SUBJECT: ISSUANCE OF AMENDMENT NO. 6 TO FACILITY OPERATING LICENSE
NPF-16, ST. LUCIE PLANT, UNIT NO. 2

ST. LUCIE PLANT UNIT NO. 2

Amendment No. 6
License No. NPF-16

SAFETY EVALUATION BY THE OFFICE OF NUCLEAR REACTOR REGULATION

Figure 3.2-2
 AXIAL SHAPE INDEX vs fraction of maximum allowable power
 level per Specification 4.2.1.3

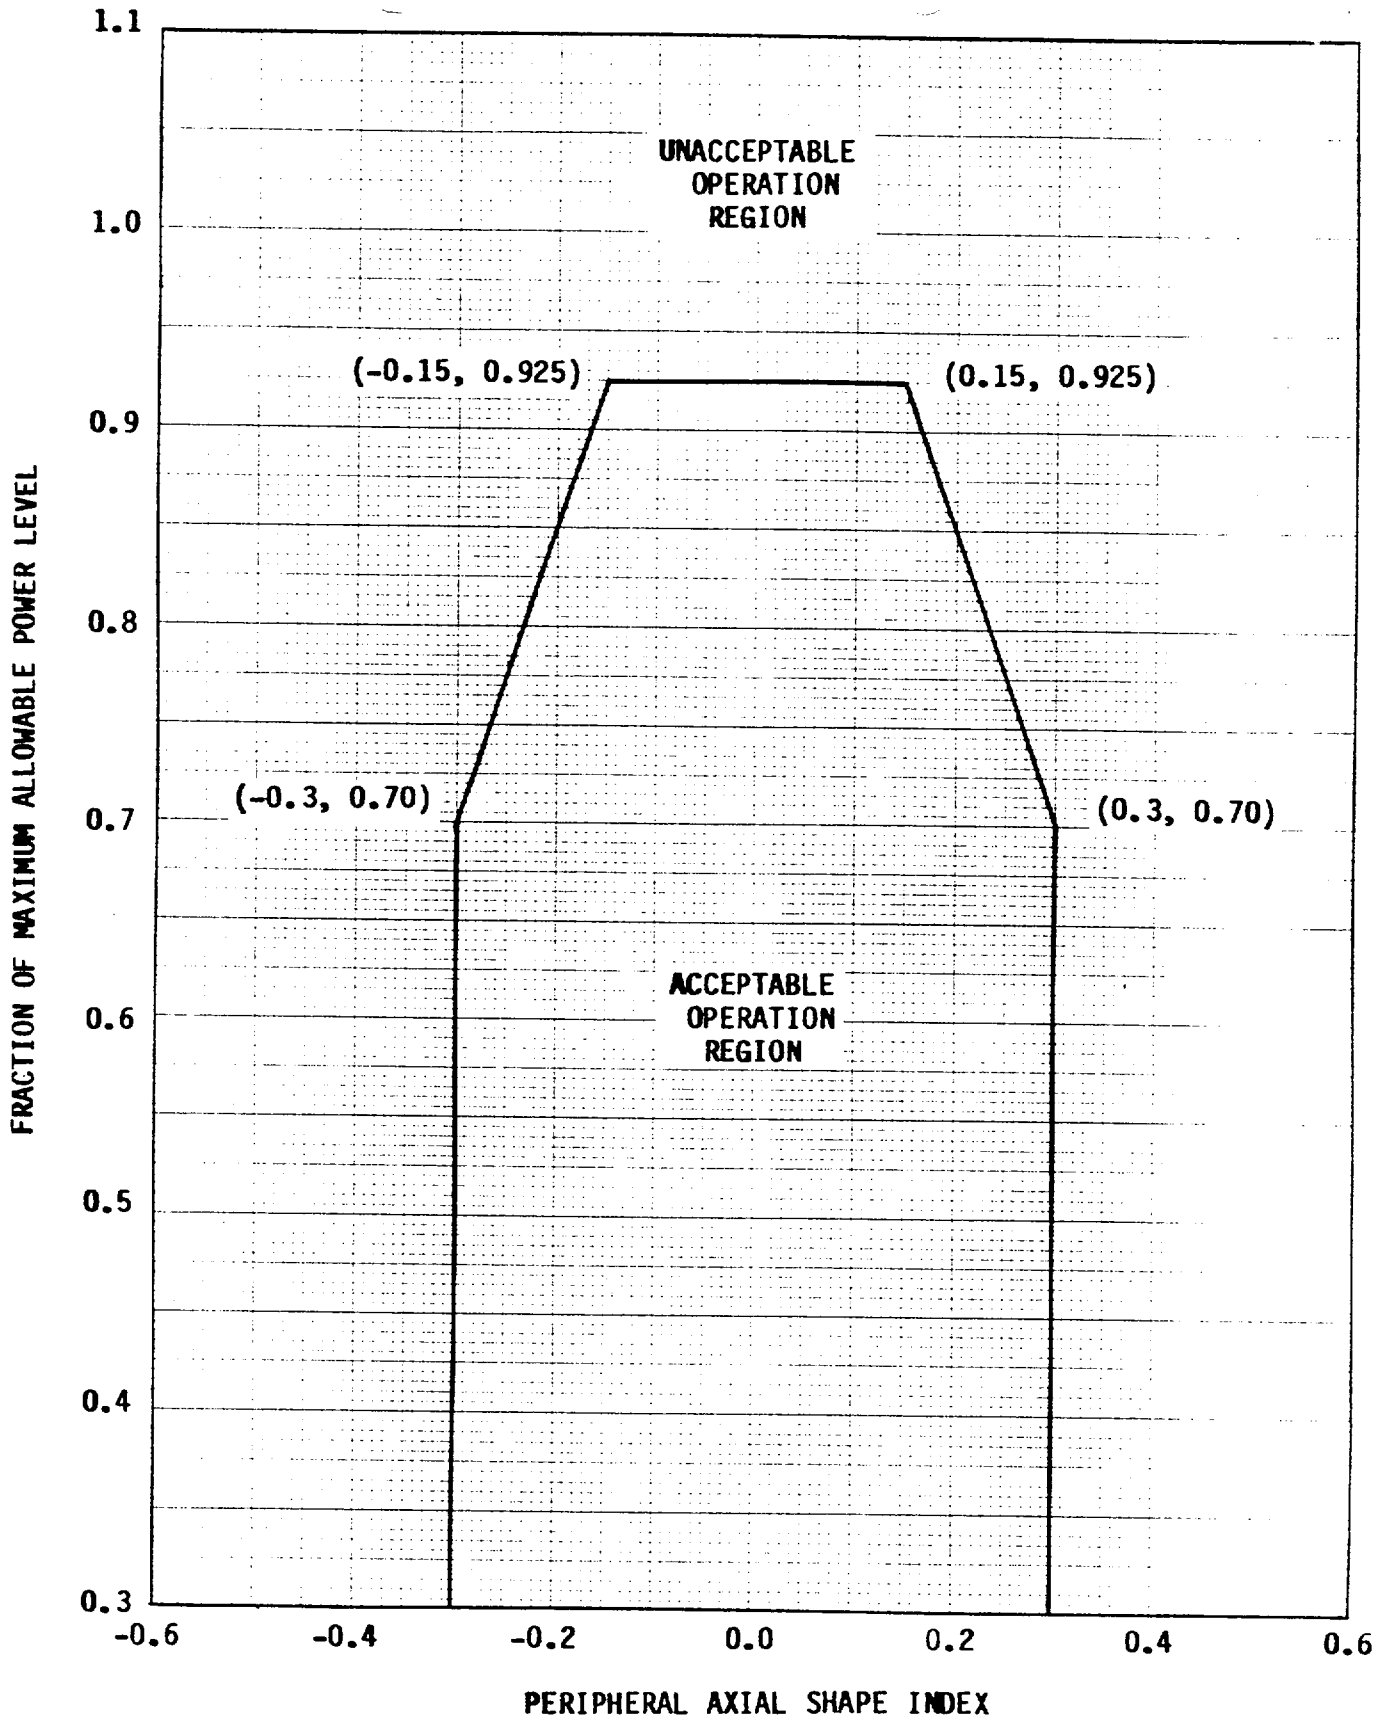
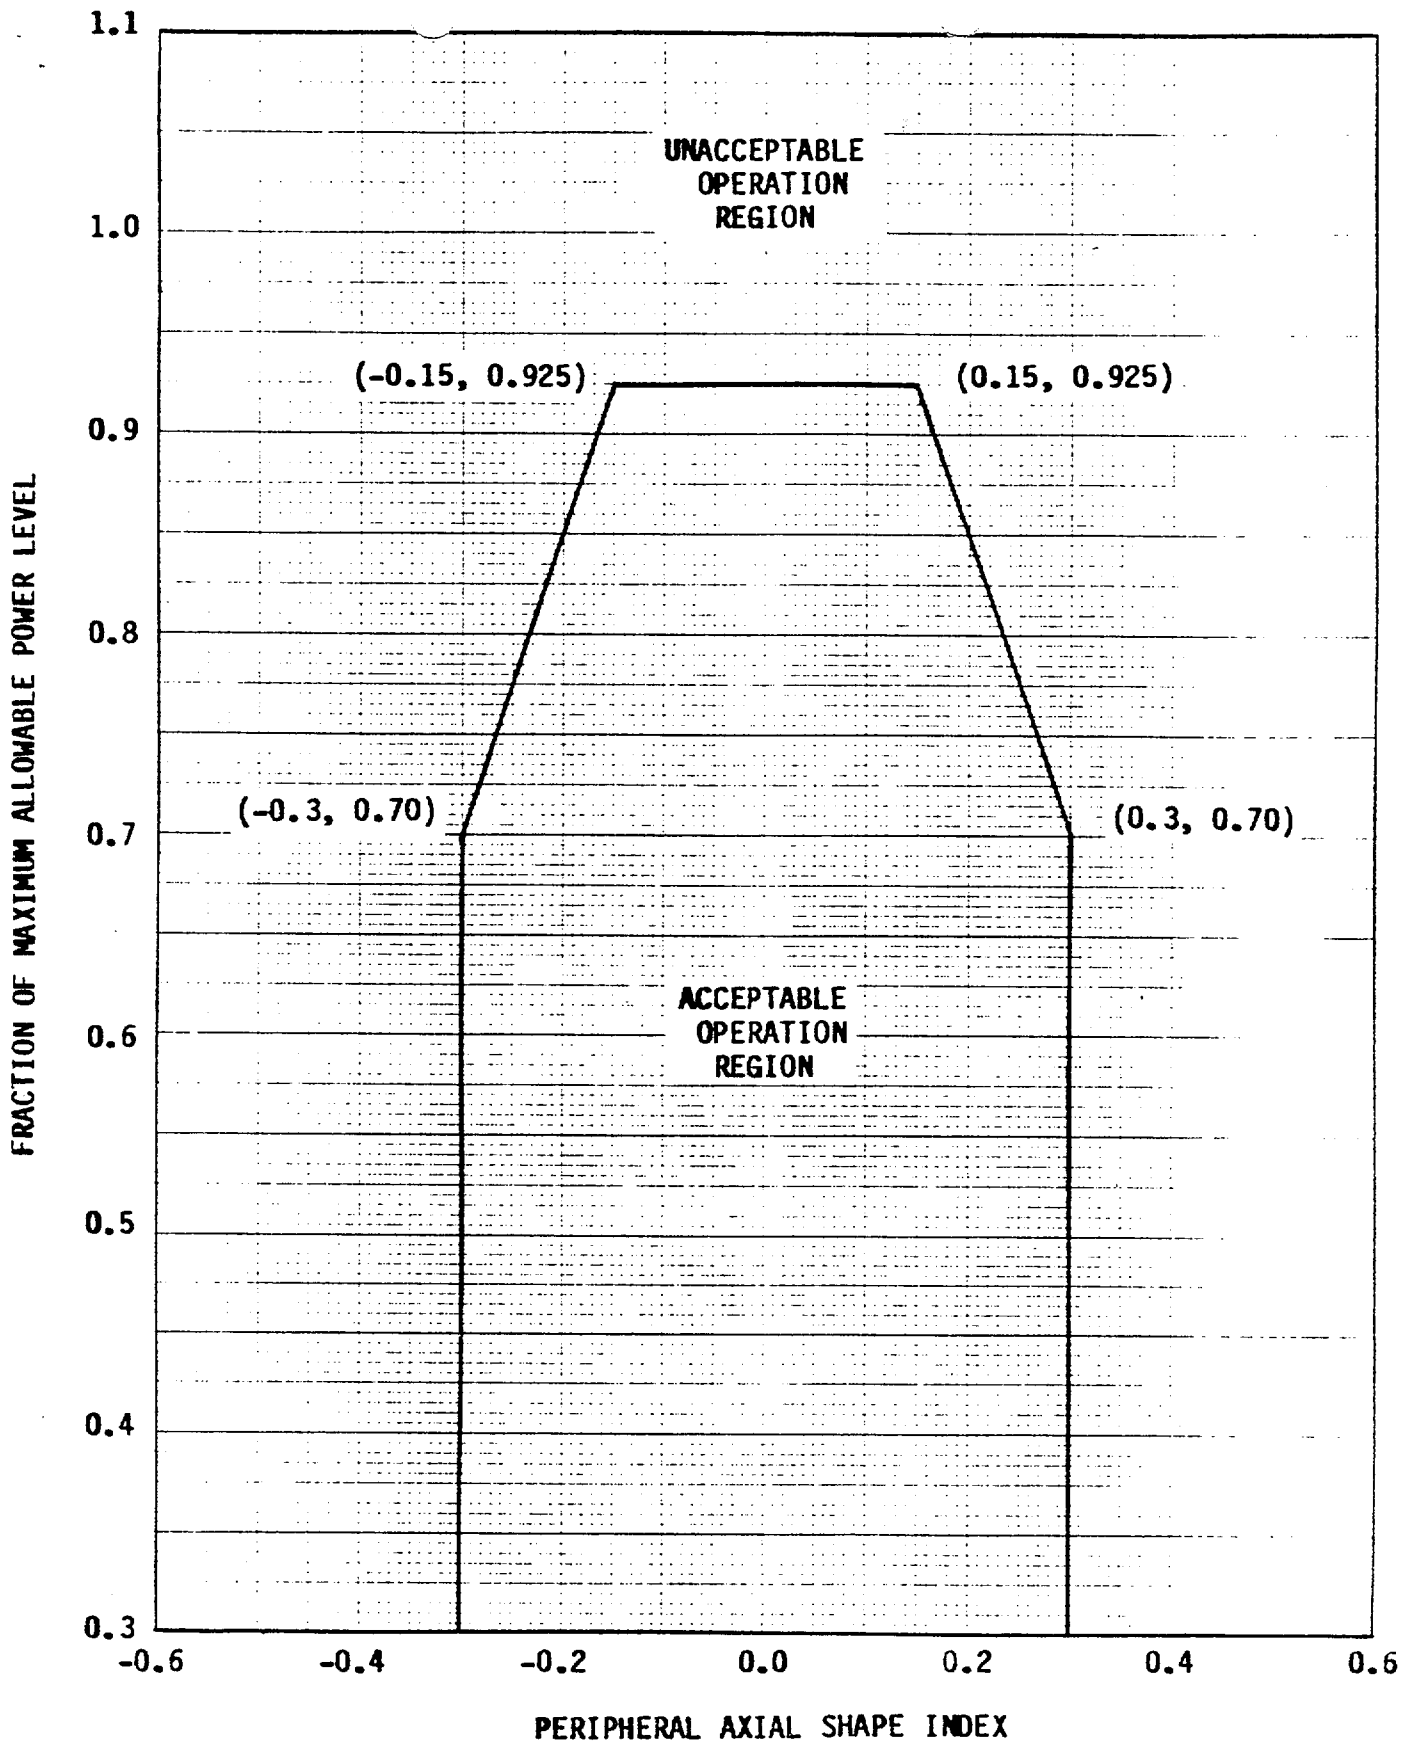
The amendment changes Axial Shape Index Figures 3.2-2 and 3.2-4 to reflect the fact that the Limiting Conditions for Operation are not needed below 30% of rated thermal power.

In a letter dated December 22, 1983 Florida Power and Light Company (FP&L) requested a license amendment to modify the St. Lucie Plant, Unit No. 2, Axial Shape Index (ASI) figures to bring them into conformance with Unit No. 1, and to reflect the fact that the Limiting Conditions for Operation (LCO) are not needed below 30% of rated thermal power.

Figure 3.2-2 and Figure 3.2-4 of the technical specifications provide conservative calculated values of the Departure from Nucleate Boiling (DNB) LCO. As the power decreases the permitted ASI becomes larger. However, for convenience it was truncated at -0.3 and $+0.3$, but the permissible ASI continues to increase as power decreases. The Local Power Density (LPD) Limiting Safety Setting Set-points (LSSS) for St. Lucie Unit 2 likewise increases as power decreases and has values of -0.4 and $+0.4$ from 80% to 0% power. FP&L has provided data that shows that the LSSS becomes more restrictive than the DNB LCO at approximately 77% power. FP&L has also provided data that show that the LSSS continues to be more restrictive as power continues to decrease.

Based on the staff review of the data submitted, the staff agrees that the LSSS value is more restrictive than the calculated DNB LCO below 30% power. Therefore, the staff approves of the proposed technical specification change allowing the LSSS to replace the DNB LCO below 30% power.
